Subject: Request for Modifications to Montgomery Downtown Environmental Assessment Project  
Technical Work Plan

Thank you for meeting with the Downtown Environmental Alliance (DEA) Technical Committee on August 22, 2016, to review the field activities completed to date and to discuss the proposed Phase II field activities for the Montgomery Downtown Environmental Project (DEAP). We appreciate your review and approval during the meeting of our proposed locations and approach for conducting the Phase II activities. In addition, we discussed a few minor modifications to the Technical Work Plan (TWP), which was approved on May 20, 2016. Those requested changes to the TWP are as follows:

**FIGURE 1**  
 County Annex III and Alabama AG's Buildings  
 Proposed Soil Vapor Sampling Locations  
 Downtown Environmental Assessment Project  
 Montgomery, AL

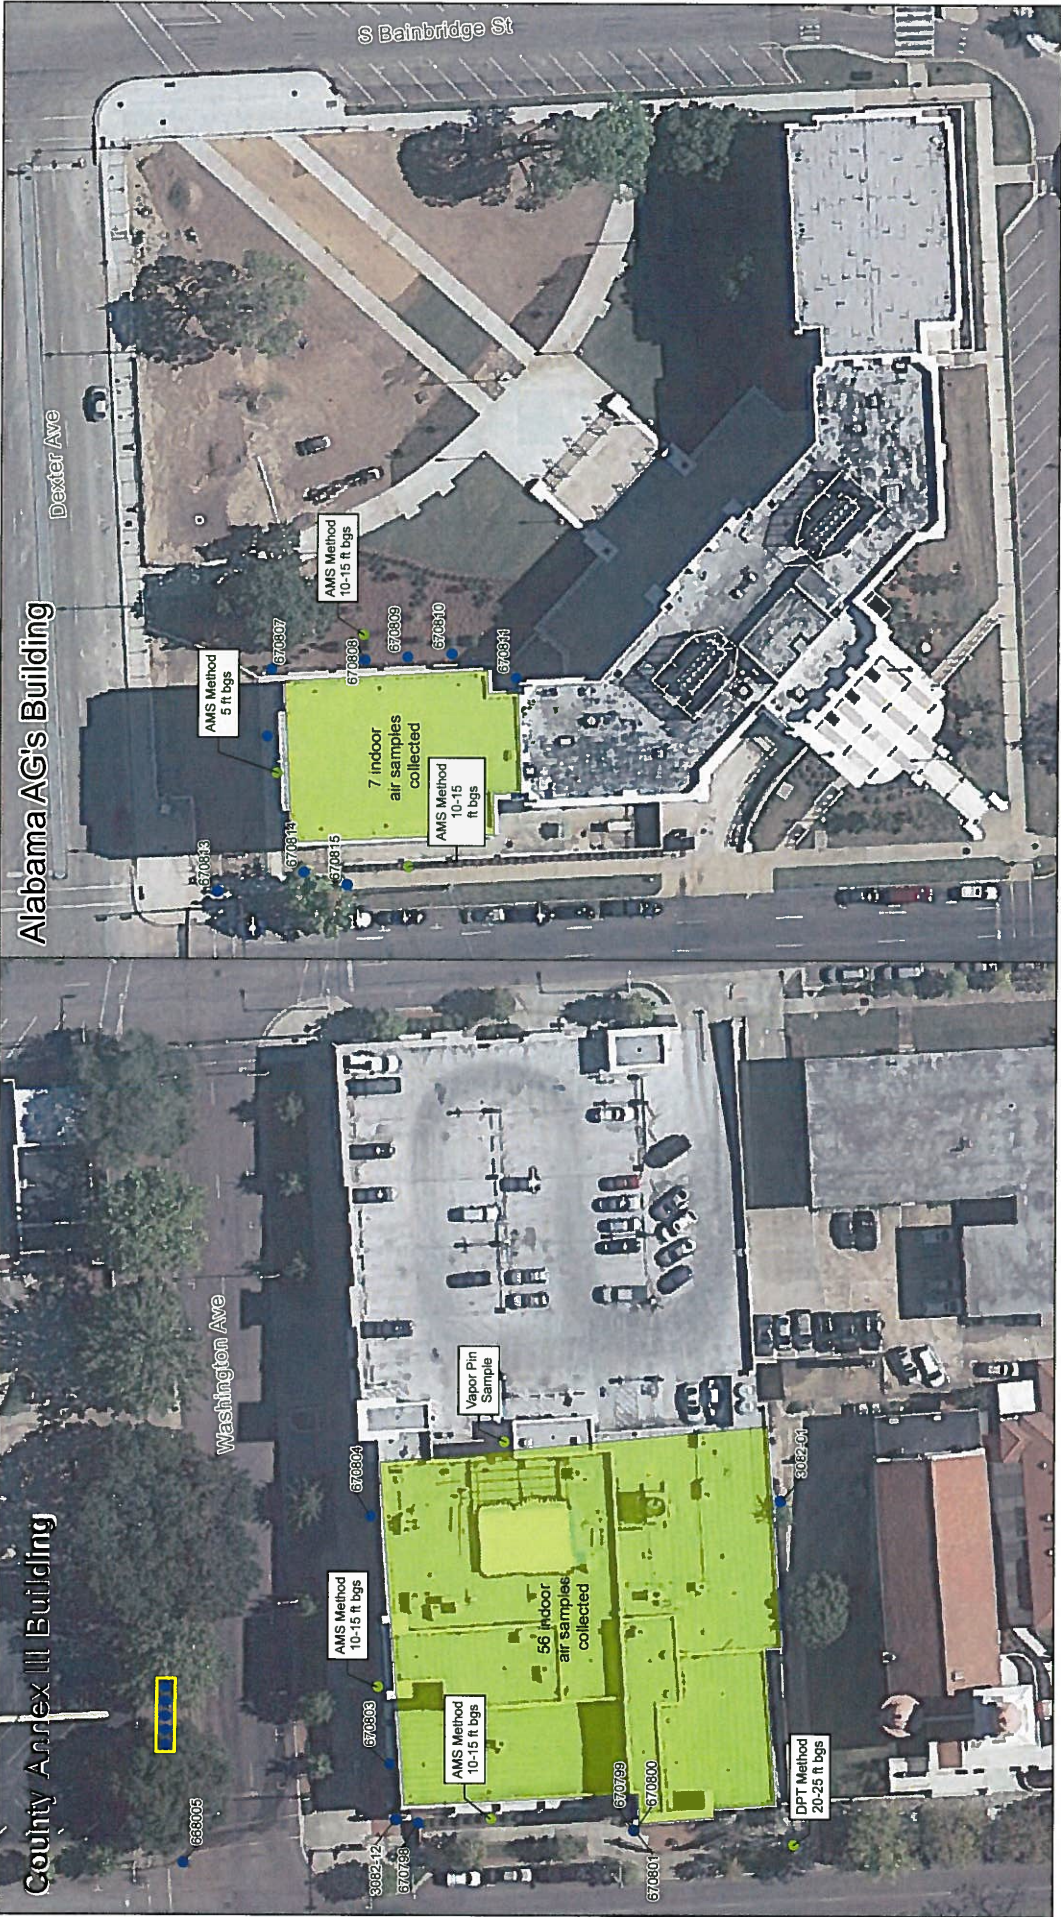
- In lieu of using Vapor Pins to collect soil vapor around the north wing of the Alabama Attorney General's (AG's) and County Annex III buildings, the DEA proposes to install temporary soil vapor sampling probes to depths of the basement floor elevation using the AMS Retract-A-Tip probing system or direct-push technology where Vapor Pins are not appropriate. The use of a Vapor Pin requires a minimum 10 × 10 feet square area of intact concrete without cracks, seams, or joints. Most areas identified adjacent to the AG's north wing and County Annex III are not of sufficient size to meet this criterion. Alternatively, temporary soil vapor probes can be installed within grassy or other uncovered areas with minimal disruption to landscaping.

Proposed locations of the soil vapor samples are shown on Figure 1. The depths and locations of soil vapor samples around the County Annex III and AG Building will be based on site topographic maps and avoidance of utility conflicts.
